CITY PLAN COMMISSION

FILE NUMBER: S223-046 SENIOR PLANNER: Sharmila Shrestha

LOCATION: Lyndon B. Johnson Freeway/Interstate Highway No. 635 at Preston

REQUEST: An application to create one 0.424-acre lot from a tract of land in City Block A/7437 on property located on Lyndon B. Johnson Freeway/Interstate Highway No. 635 at Preston Road/State Highway No. 289, northeast corner.

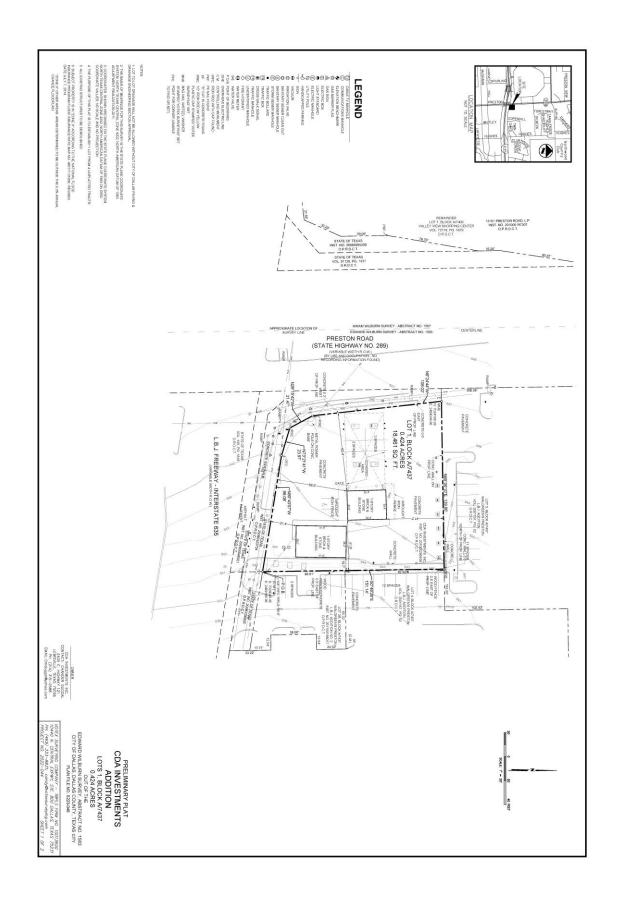
15. On the final plat, dedicate 72.5 feet of right-of-way (via fee simple) from the established center line of Preston Road/State Highway No. 289. Section 51A 8.602(c).

- 19. On the final plat, show recording information on all existing easements within 150 feet of property.
- 20. On the final plat, show how all adjoining right-of-way was created.
- 21. On the final plat, show distances/width across all adjoining right-of-way.
- 22. On the final plat, show all additions or tracts of land within 150 feet of property with recording information.

- 24. On the final plat, change "L.B.J. Freeway-Interstate 635" to "Lyndon B. Johnson Freeway/ Interstate Highway No. 635".
- 25. On the final plat, change "Preston Road" to "Preston Road/State Highway No. 289".
- 26. On the final plat, identify the property as Lot 8 in City Block A/7437. Ordinance 1A, Page 131 pages 131-148, Section 2 (passed August 13, 1872).
